SUBJECT: TECHNICAL COMMENTS ON THE DRAFT USER'S GUIDE FOR THE OPEN ITEM
TRACKING SYSTEM (OITS)

NRC COMMENTS ON THE OPEN ITEM TRACKING SYSTEM AND USER'S GUIDE

TYPES OF OPEN ITEMS

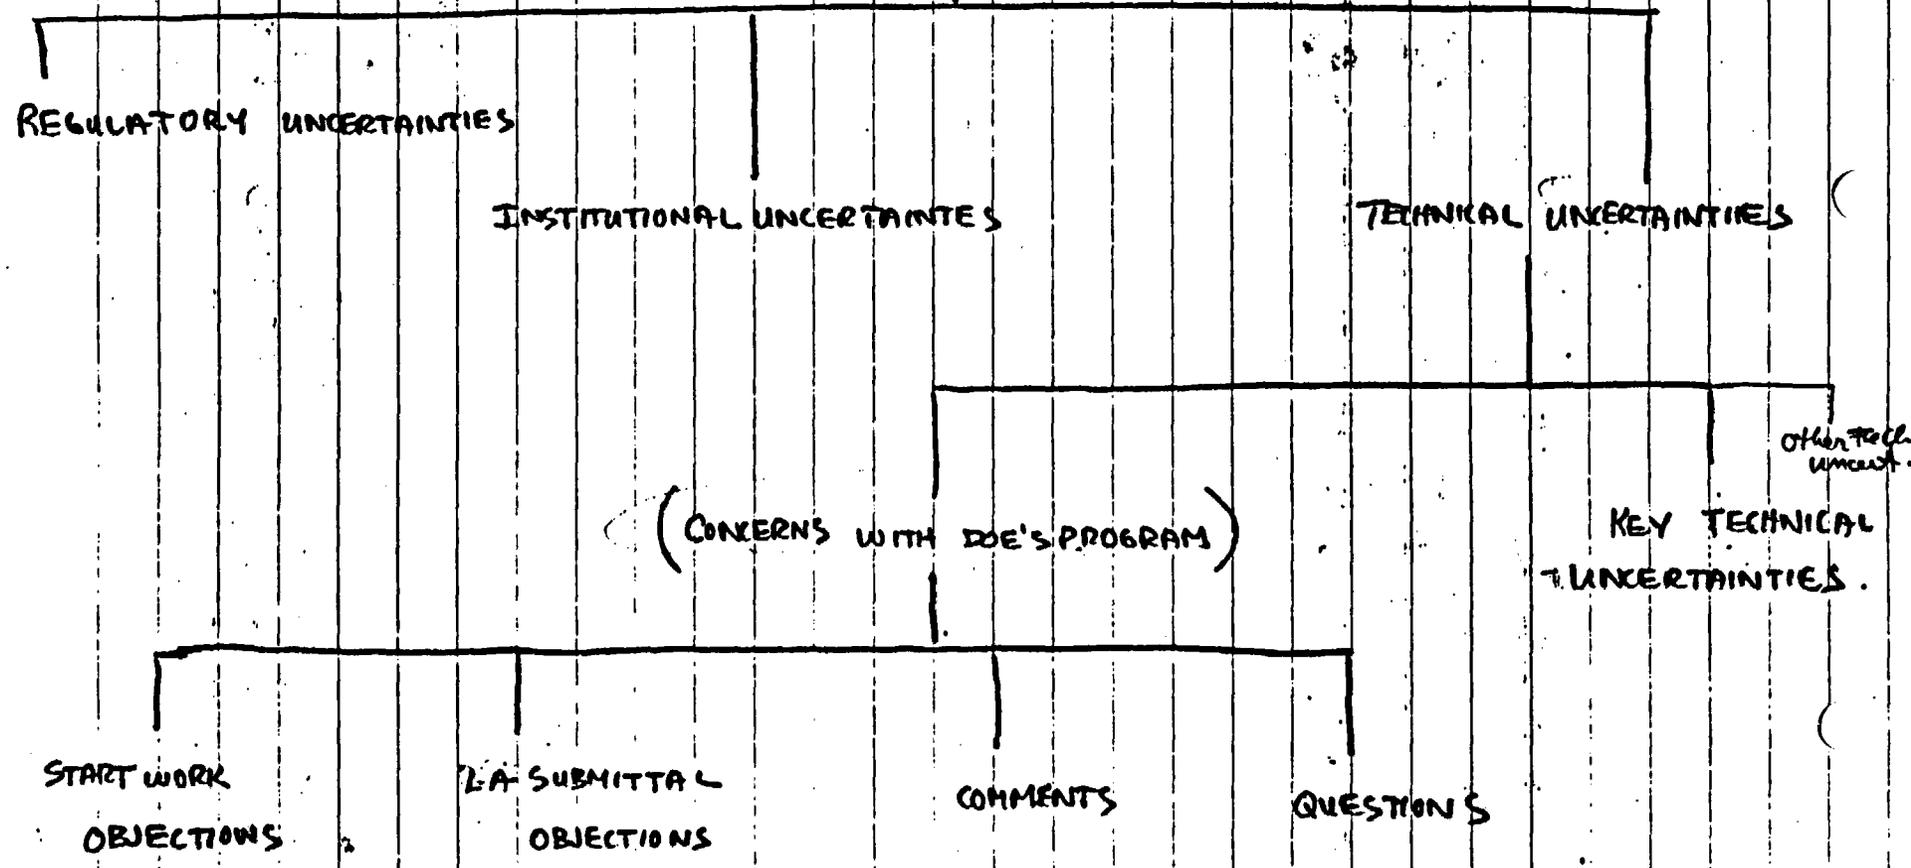
- f) Prepare a new Chapter 2 entitled "Open Item Tracking Process and System Description" with the following subsections:
- 2.1 "Open Item Identification and Tracking Process" (NRC staff will provide the input to this section). Include the figure "Types of

Open Items" in this section, illustrating the various types of open items that are being tracked in OITS (See Attachment 3).
